DATE:18 February 2024
FROM: Scott England
VIA:File Share

SUBJECT:
ADDENDUM #01
LINDENWOLD SCHOOL #4
RYEB Project #5743F, H & O

PROJECT TITLE:
**BUILDING RENOVATION
 LINDENWOLD SCHOOL #4**

H-105

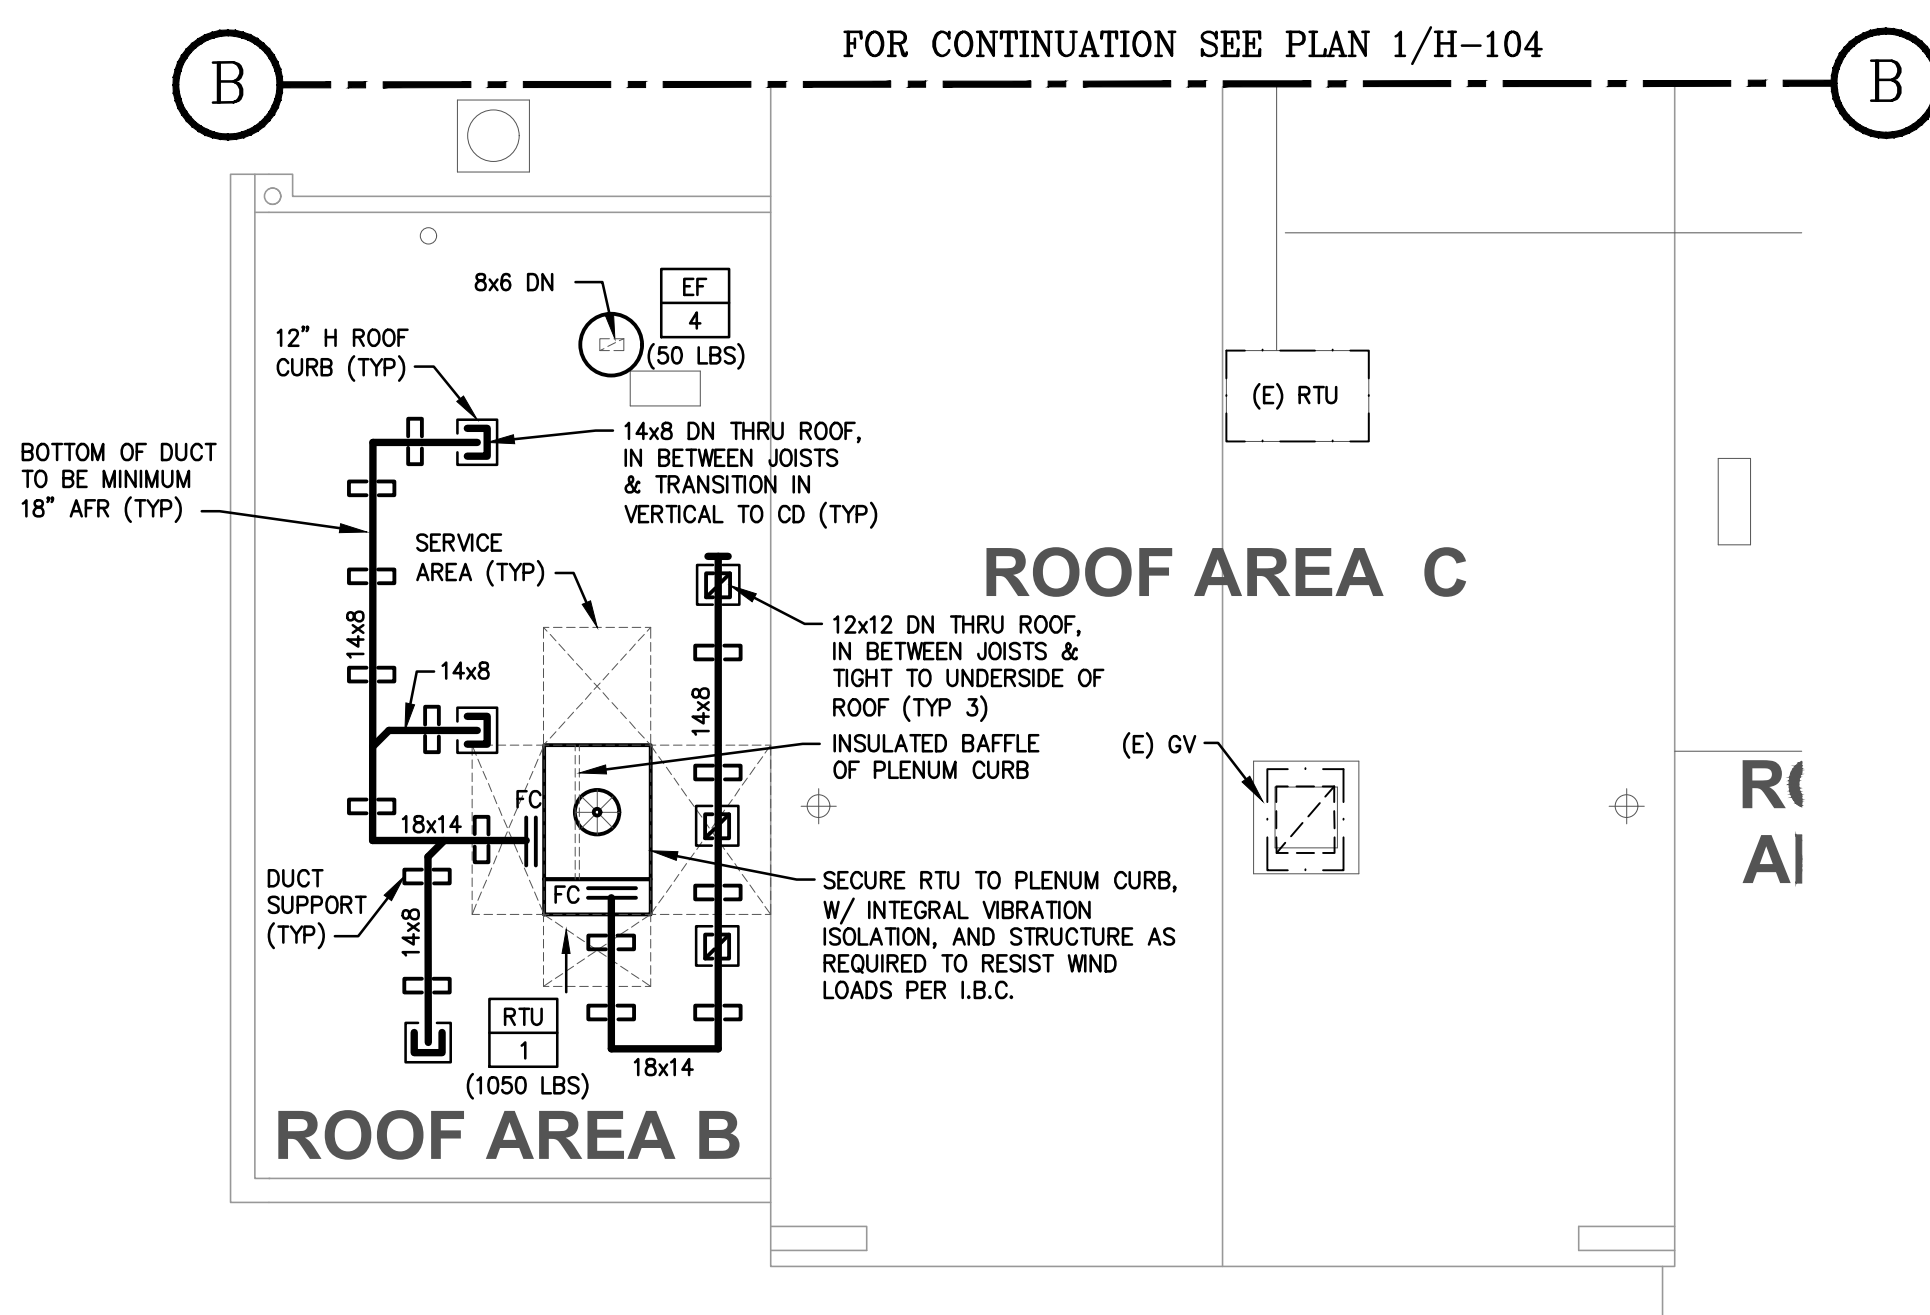
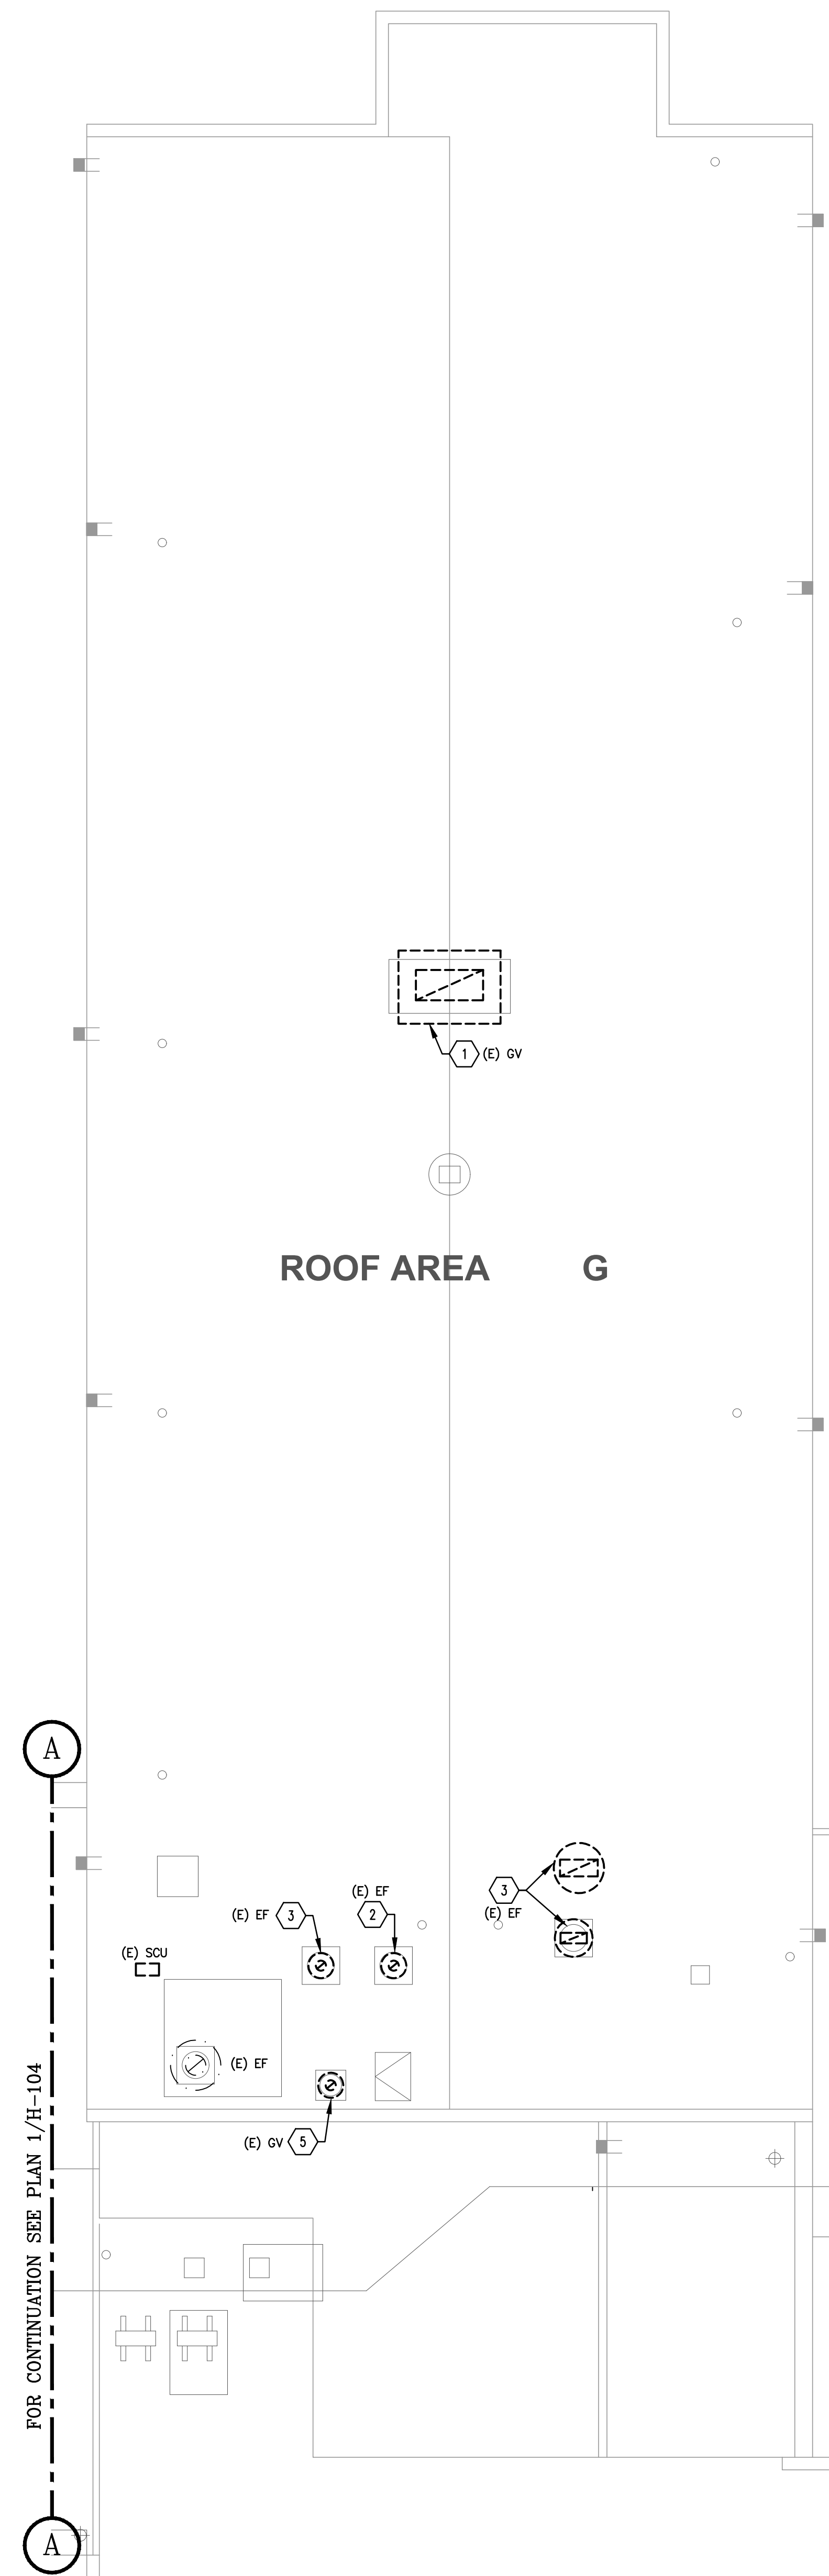
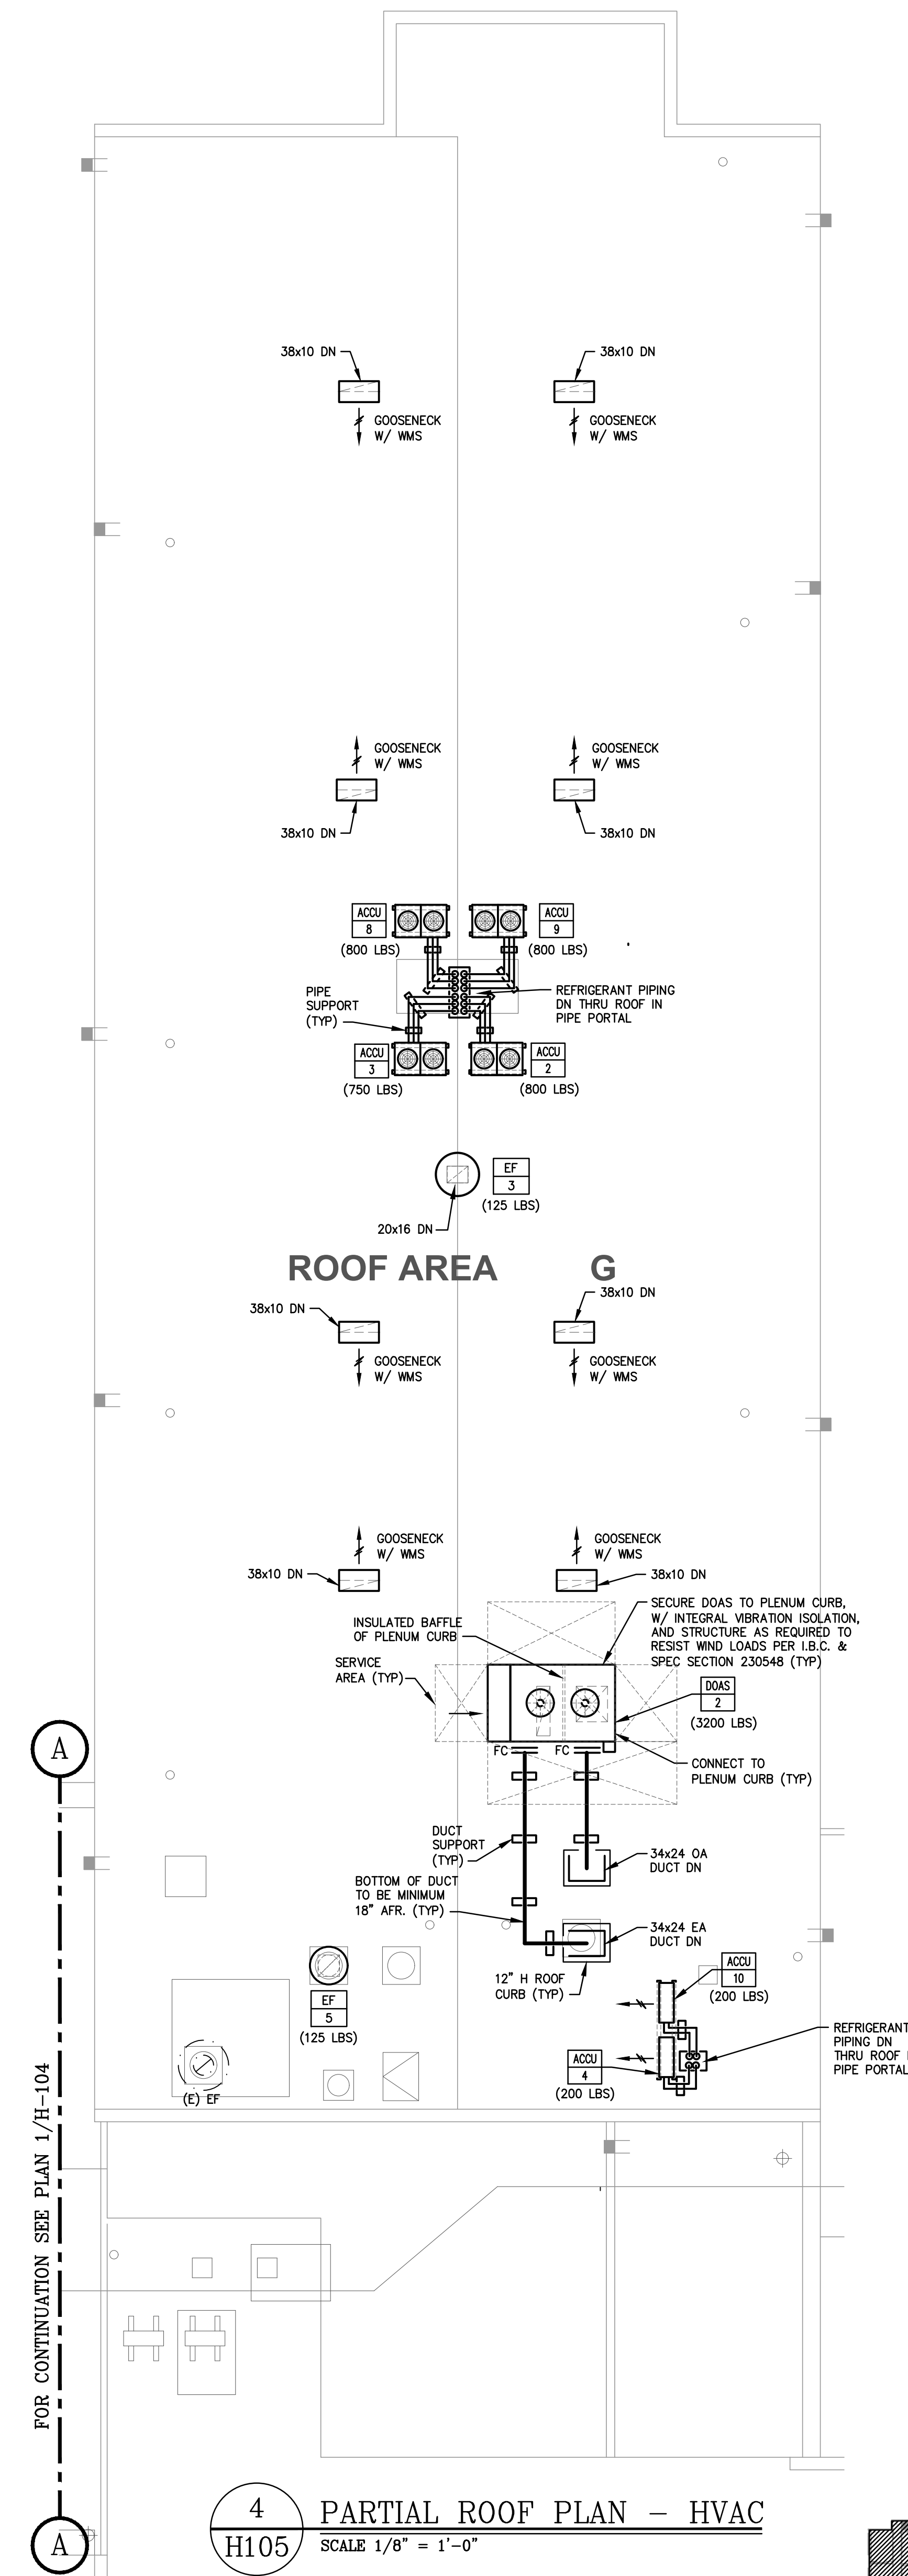
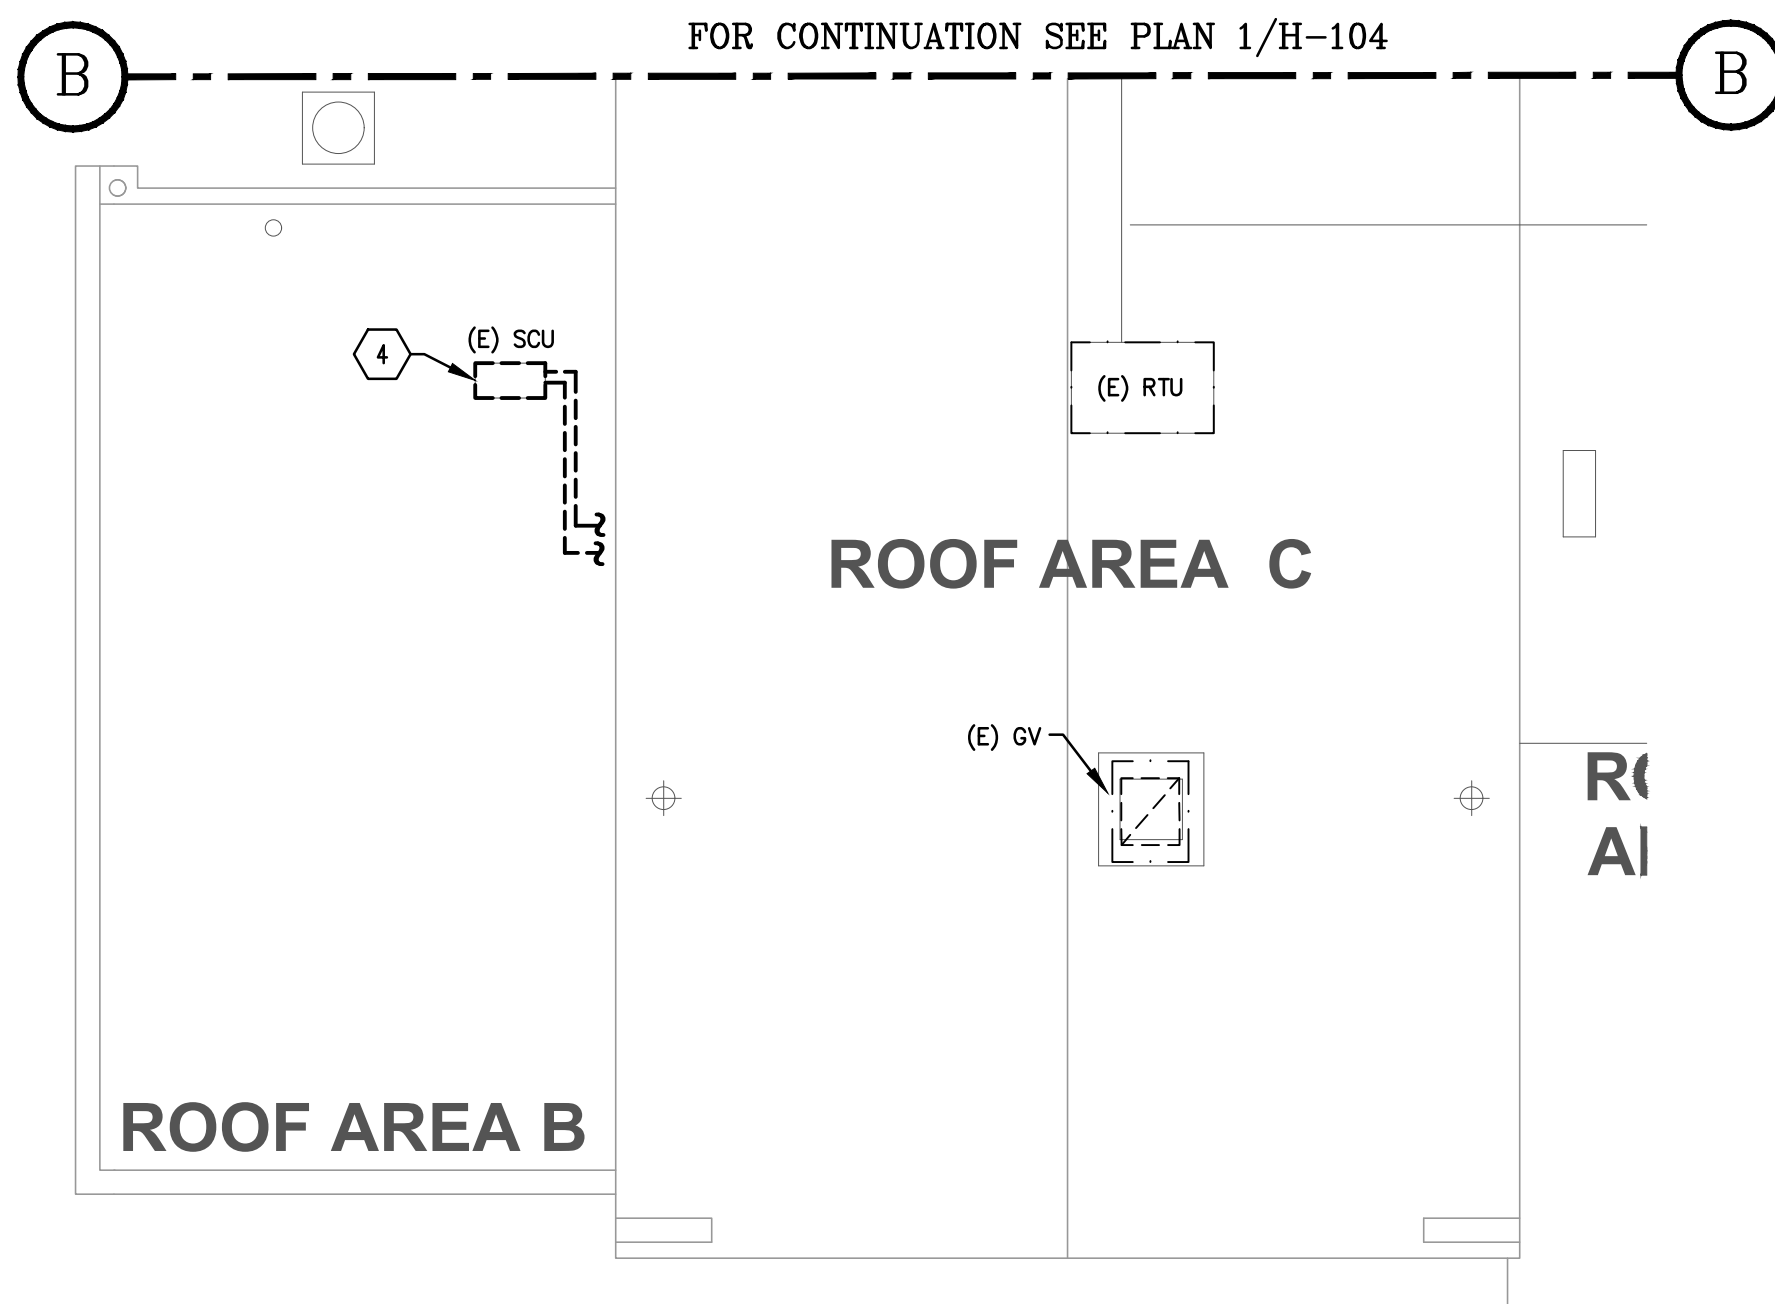
1. **Question:** Note 1 on H-104 is calling for all Supply, Return, and Exhaust duct above roof shall be Dual-Tech prefab duct. There are goosenecks on the roof which appear to be acting as relief. Do the goosenecks also need to be Dual-Tech.

2. **Question:** Note 1 on H-104 calls for duct on roof to be Dual-Tech or Approved Equal. Since this ductwork is not listed in the spec, please provide approved equal products.

Response: HVAC New Work Note #1 has been amended on drawings H-104 & H-105, an attached to this addendum.

Response: HVAC New Work Note #1 has been amended on drawings H-104 & H-105, an attached to this addendum.
